BEFORE THE
LOUISIANA PUBLIC SERVICE COMMISSION

DOCKET NO. I-36175

CLECO POWER COMPANY (CLECO),
EX PARTE

STAFF REPORT

Figure 2. Cleco's natural gas prices forecast (nominal dollars) and conversion to real dollars at Cleco's assumed 2.55% inflation

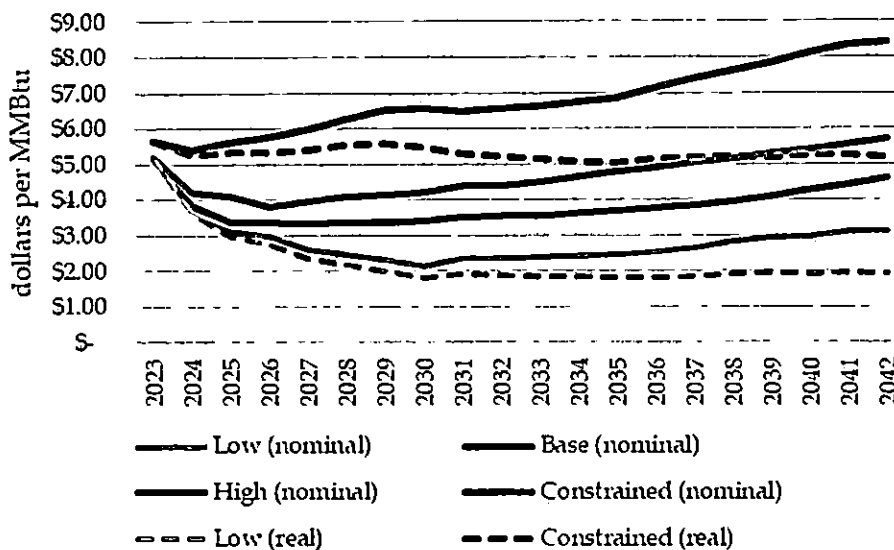
To reflect potential volatility of natural gas prices, Staff asked Cleco to examine the potential for a wider range of outcomes for natural gas prices in its scenarios. Rather than broaden the range between the high and low outlooks, Cleco added a fourth outlook, “Constrained Supply” (see Figure 2), which is an acceptable approach. Based on Cleco’s 2.55% inflation assumptions beginning in 2023, this translates into low-case prices of \$1.93/MMBtu by 2042; and in the constrained-price case, \$5.20/MMBtu by 2042. The range across the futures is probably wide

enough to produce useful tests of the economics of its three portfolios. Cleco used the Constrained Supply case as a sensitivity test in three of its scenarios.

Figure 4. Cleco's energy price (LMP) outlooks in each scenario/sensitivity

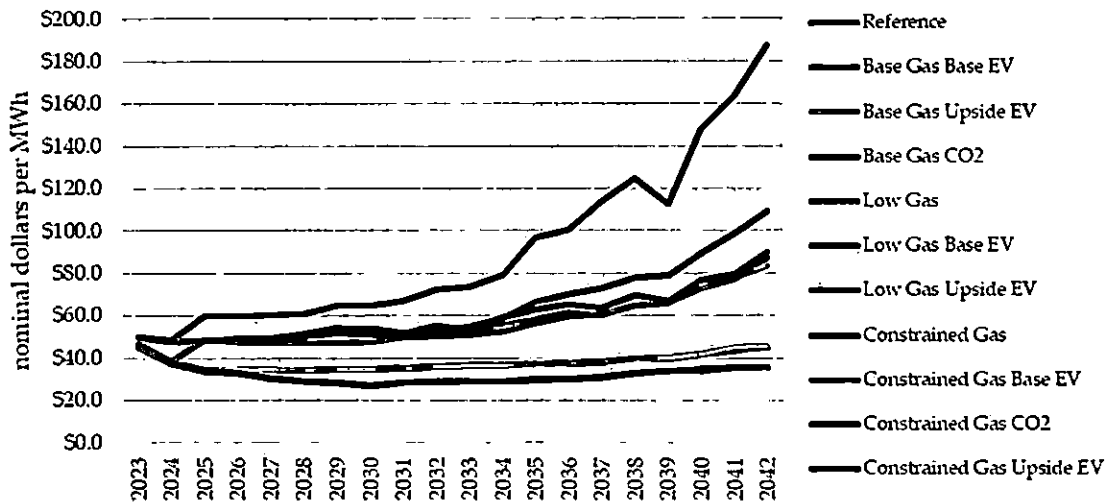
This is a large number of scenarios/sensitivities against which to test potential portfolios, and the task could become pointlessly time-consuming if every portfolio must be tested in every scenario/sensitivity. Cleco can perform the task more efficiently by using only a few, well-chosen scenarios. For example, although Cleco defined 12 scenario/sensitivities, the difference in energy prices (LMPs) is very small between several of the cases (see Figure 4), so several could be eliminated without reducing the usefulness of the scenario exercise. A smaller number of scenario/sensitivities, perhaps four, should be sufficient to test the portfolios. Cleco should also avoid the temptation of thinking of any scenarios as “most likely.” Scenarios do not represent probabilities—they represent possibilities.
